GEORGETOWN-SCOTT COUNTY PLANNING COMMISSION

AGENDA

January 11, 2018

TOP GUN AUTO SALES
Staff Report to the Georgetown-Scott County Planning Commission
January 11, 2018

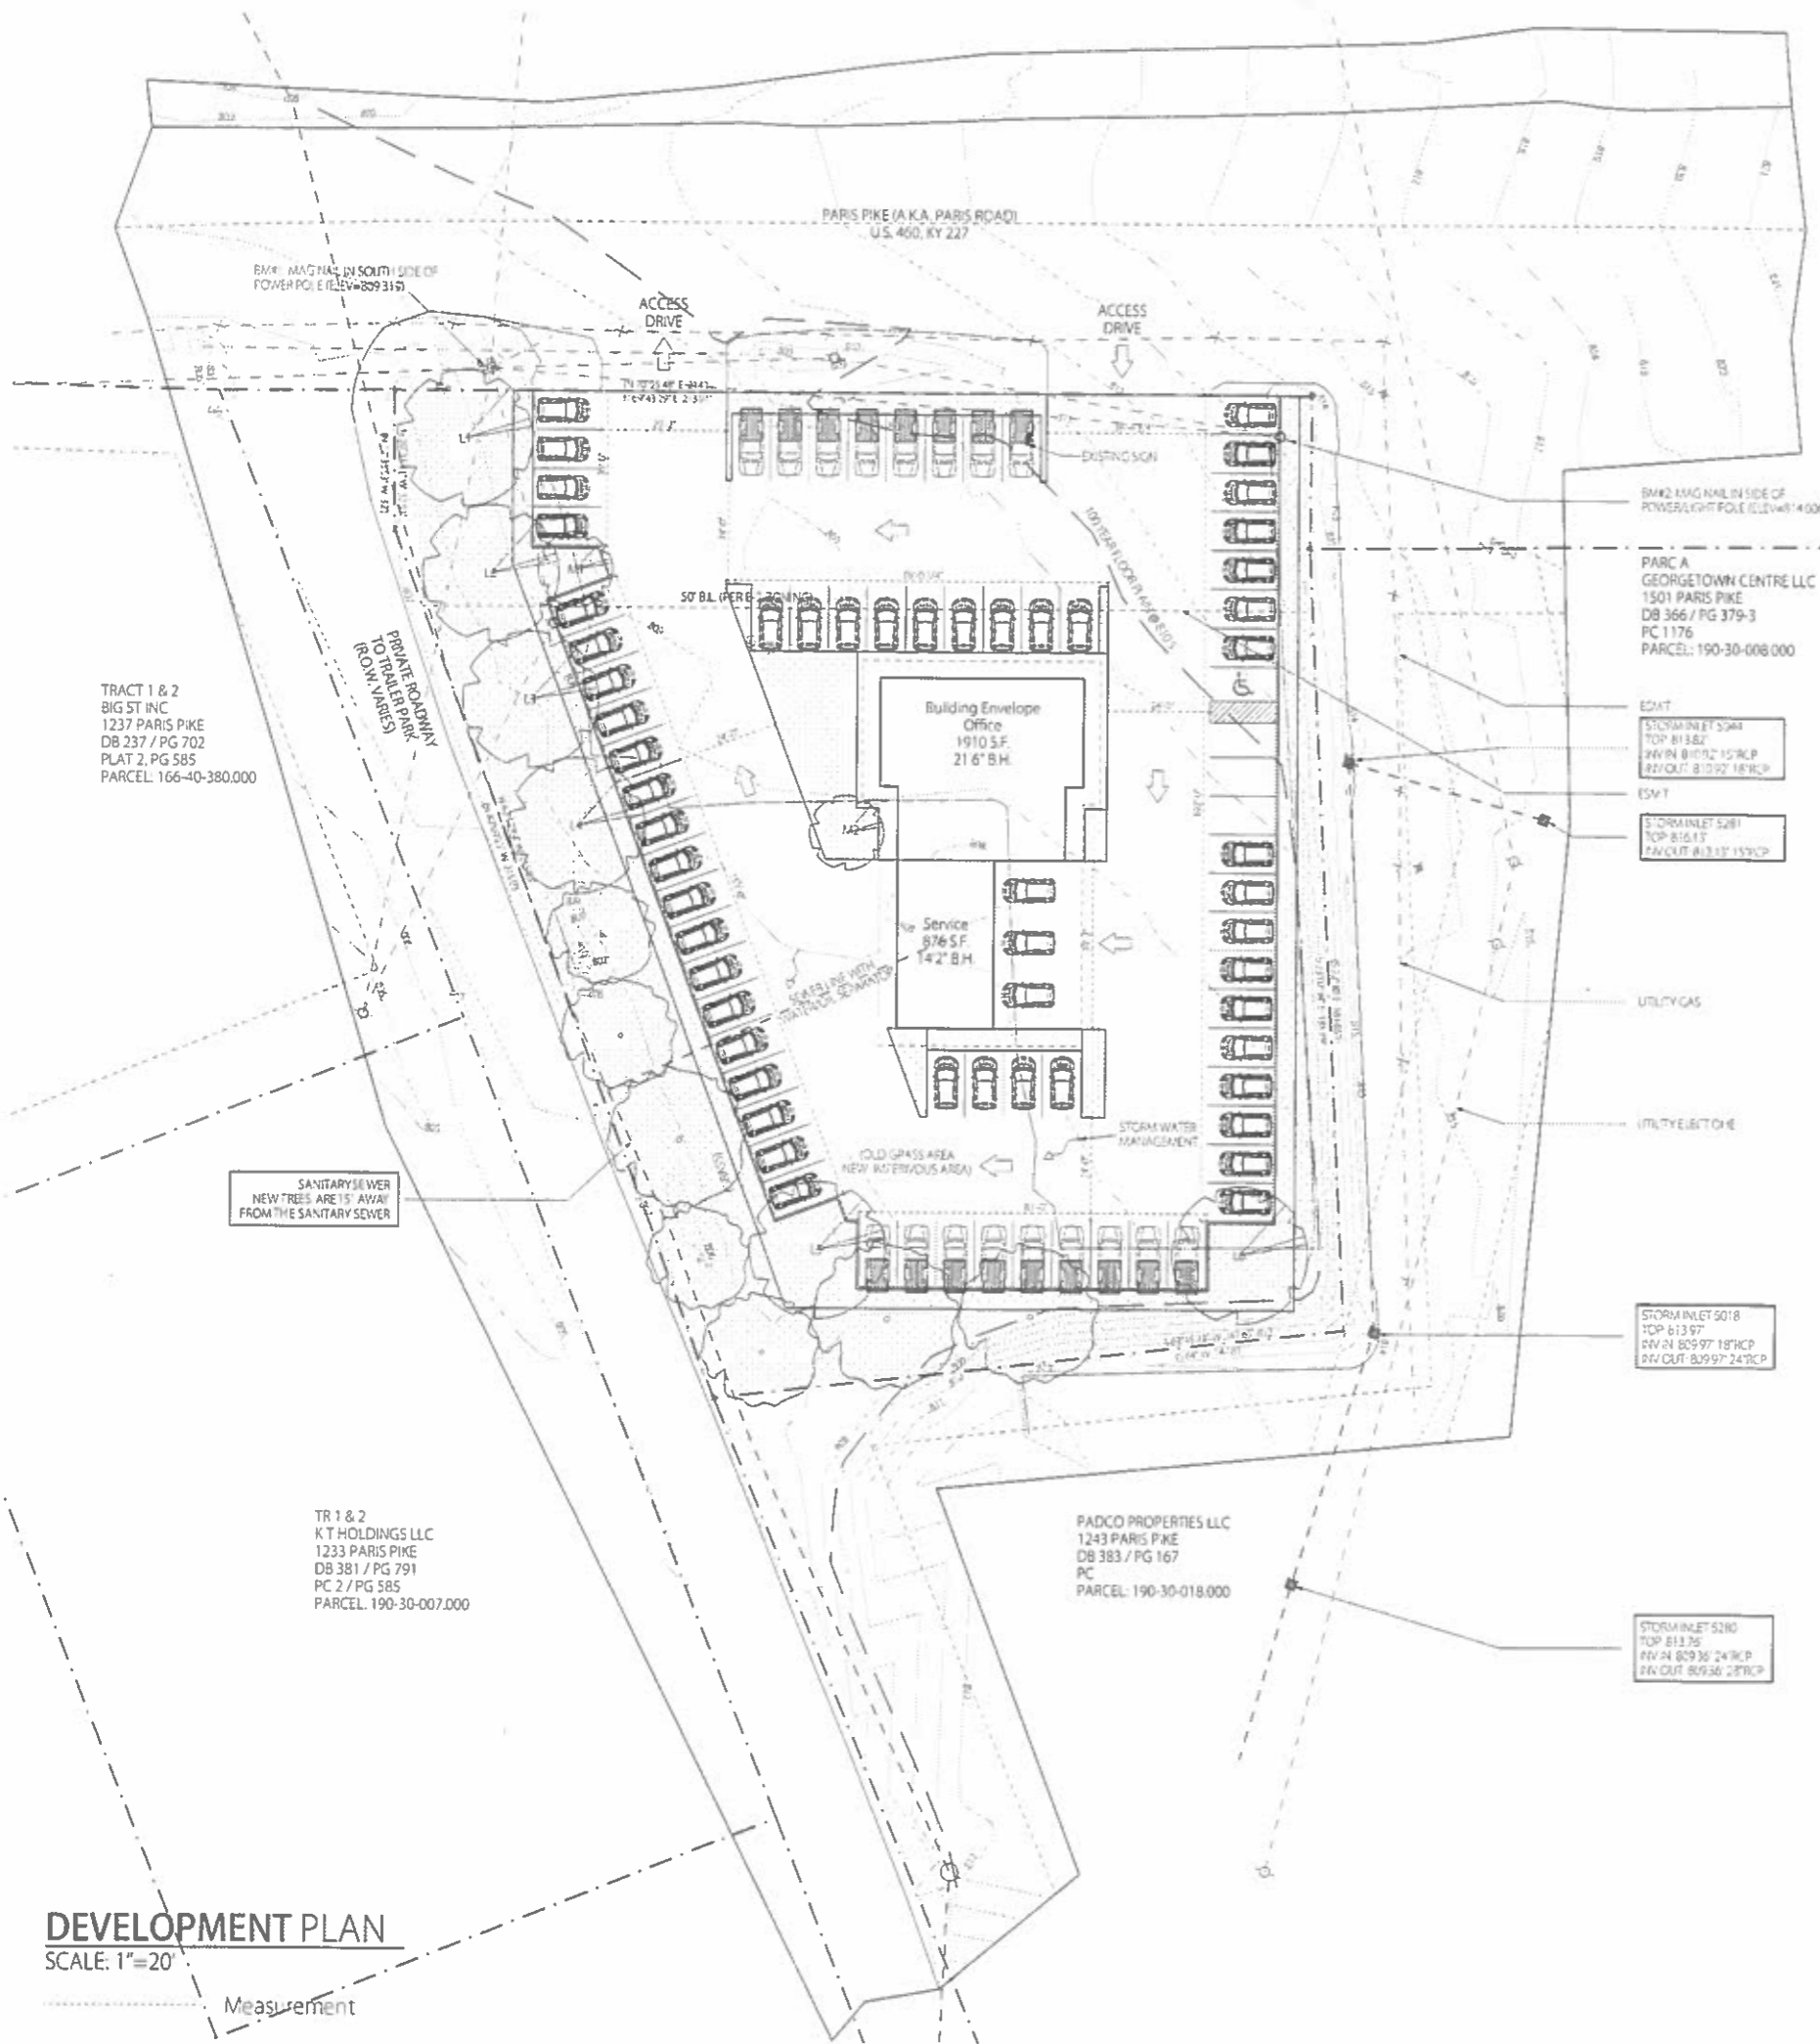
Sidewalks: Internally, the Applicant is proposing sidewalks around the office portion of the building. The Applicant is requesting a waiver to the sidewalk along Paris Pike. A sidewalk along Paris Pike would need to be constructed in the right-of-way for Paris Pike with an encroachment permit from District 7 of KYTC. Staff recommends denial of this waiver. The *Subdivision and Development Regulations* state, "All developments shall be required to provide adequate pedestrian access to parking lots, off-site sidewalks, and facilities commonly used by residents. It has been the practice of the Planning Commission to require infrastructure upgrades of this type as development occurs.

The Applicant meets the tree requirement along the western boundary with a combination of existing trees and new plantings. The Applicant has not indicated what will be used along this boundary to meet

the 18" continuous planting, hedge, fence, or wall. The Applicant has not shown any of the required screening of the vehicular use area along Paris Pike.

The Applicant is proposing to preserve roughly 10% of the lot area in existing canopy. The Applicant will need to provide an additional 12% canopy coverage to meet the canopy requirements. The Applicant will meet this requirement with the trees shown on the plan.

Staff recommends approval of the Preliminary Development Plan, but not the requested waivers, with the following conditions of approval.

1. The Applicant shall comply with the requirements of the *Floodplain Management Ordinance*.
2. A Final Stormwater Management Plan must be submitted and approved by the Planning Commission Engineer prior to approval of the Final Development Plan. Development must meet all requirements of the Georgetown Stormwater Manual.

7. A final specie-specific landscape plan shall be provided along with the Final Development Plan.

CONCEPTUAL PLAN FOR ZONE CHANGE OF KDC-GEORGETOWN LAND, LLC PROPERTY
WYNDMERE APARTMENTS - PHASE 3
3189 PARIS PIKE (US-460)
GEORGETOWN, KENTUCKY

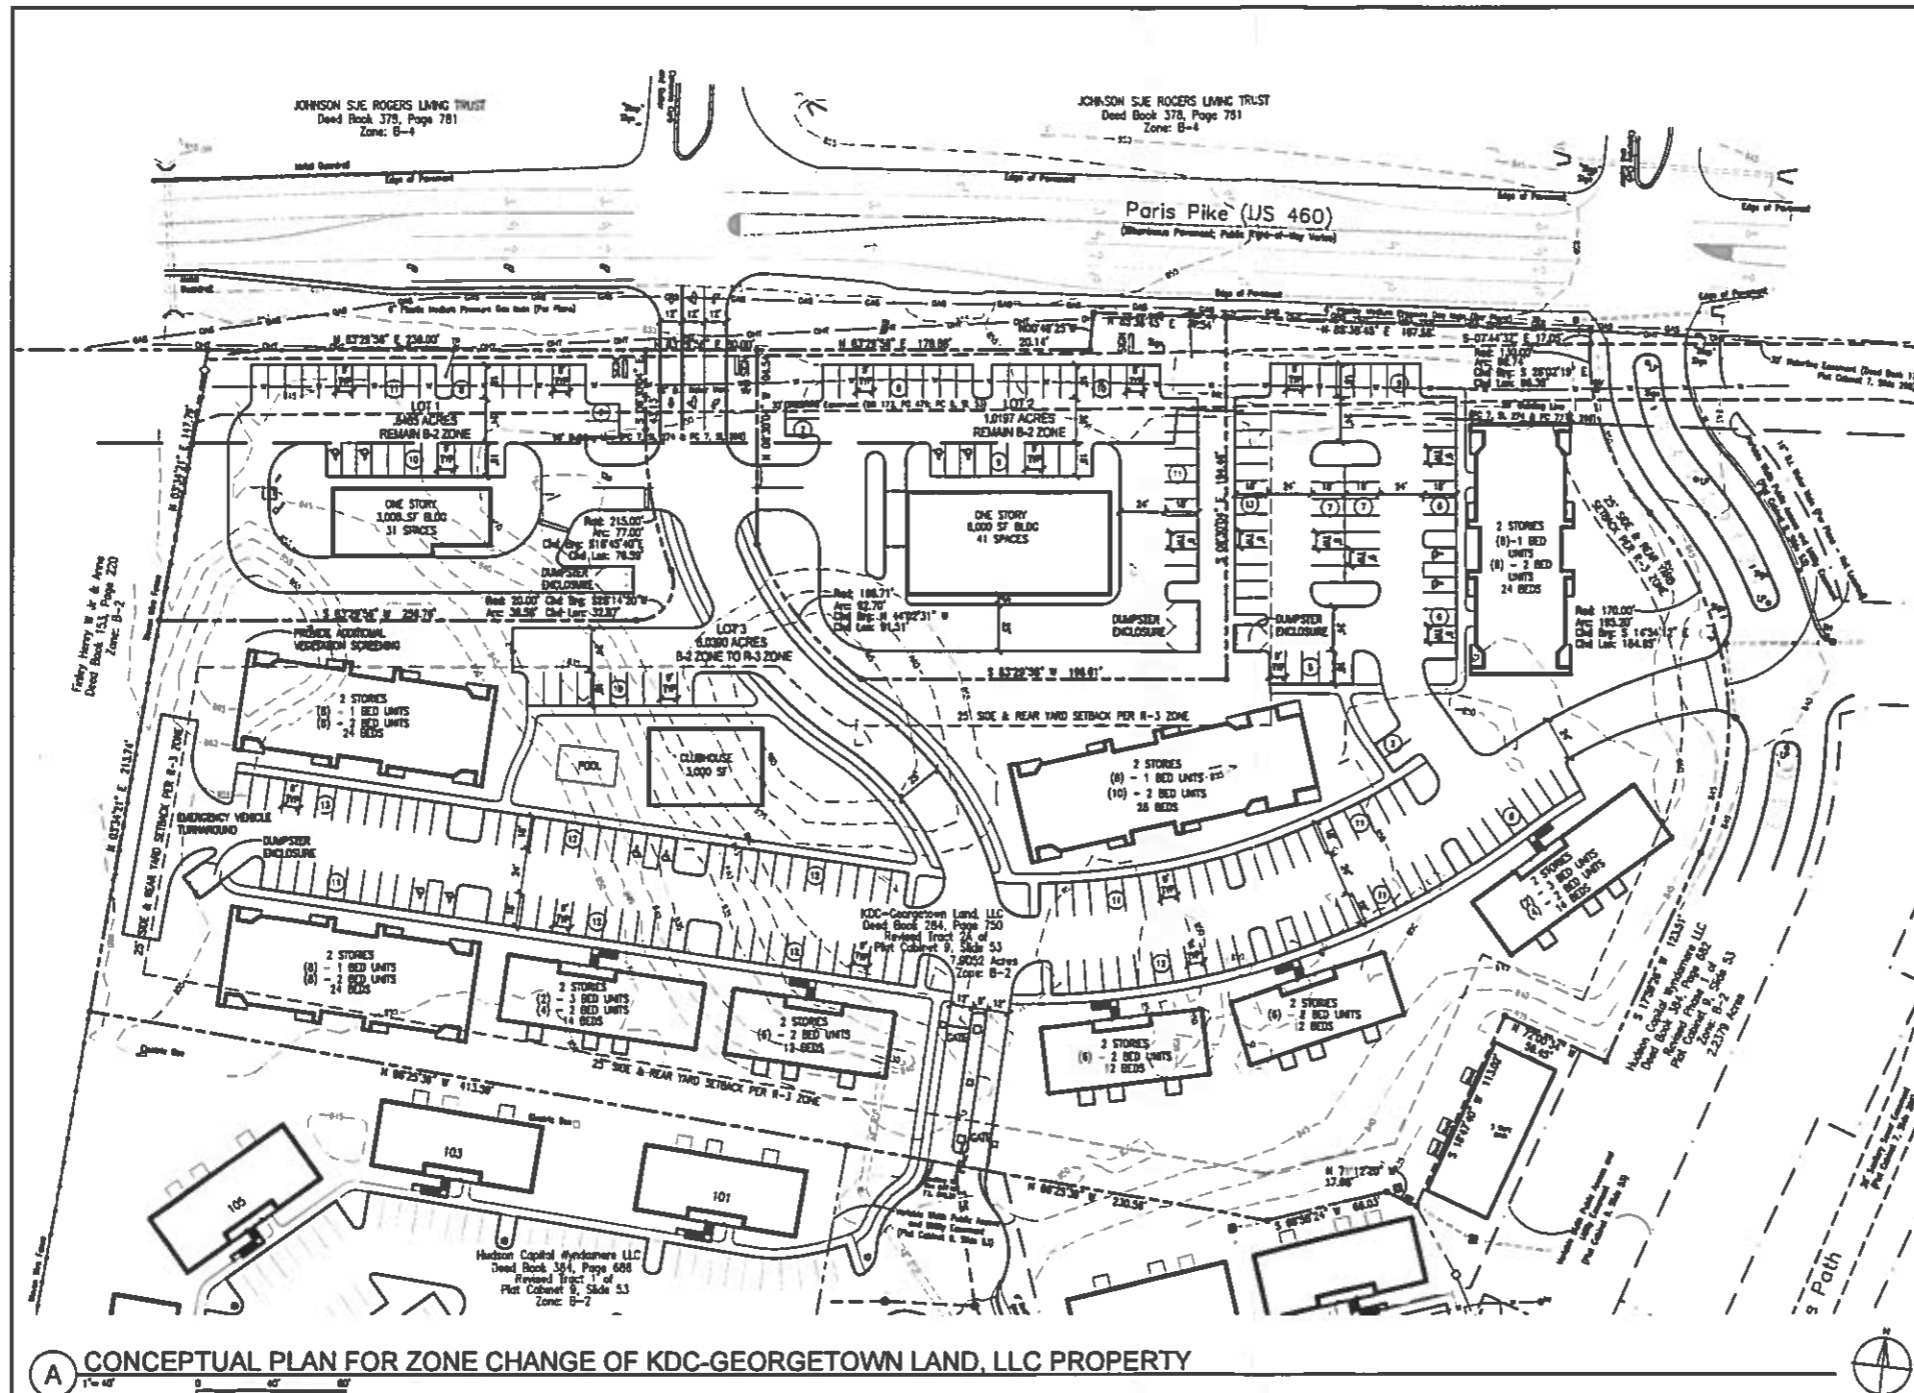
The Applicant is proposing two commercial outlots with this concept plan. These lots will have frontage along Paris Pike. The two commercial lots will have parking and trash facilities independent from each other and the surrounding multi-family development.

The proposed parking shown for the commercial outlots appears to be sufficient for the purposes of the concept plan. Final totals of parking spaces will need to be determined at the Preliminary Development stage when specific uses of these lots can be determined.

The Applicant is seeking a variance to the parking requirements as a part of the concept plan review. Based on the number of 1, 2 and 3-bedroom units being proposed by the Applicant on the concept plan, the Applicant would need to provide 208 parking spaces. The Applicant is proposing 192 parking spaces. The variance being requested would reduce the required parking for the 2 & 3-bedroom units from 2.5 parking spaces per unit to 2.25 parking spaces per unit. Staff recommends approval of this variance, because it is not a significant reduction in the required parking. It is also consistent with the parking required for the Phases I & II.

The Applicant is also seeking a variance to reduce the side and rear yard setbacks from 25 feet to 15 feet for the residential development. The concept plan shows several of the multi-family buildings crossing the 25-foot setback line.

For multi-family buildings that encroach on the 25-foot setback from either neighboring developments or the commercial outlots, staff recommends these buildings be allowed to encroach on the setbacks as long as two conditions are met. First, the average distance from the building to the property line must be 25 feet. Second, additional screening should be provided in areas where the multi-family buildings are closer than 25-feet to the commercial outlots/neighboring developments.

1. The Applicant shall return to the Planning Commission for Preliminary Development Plan approval.
2. All applicable requirements of the *Zoning Ordinance* and *Subdivision and Development Regulations*.
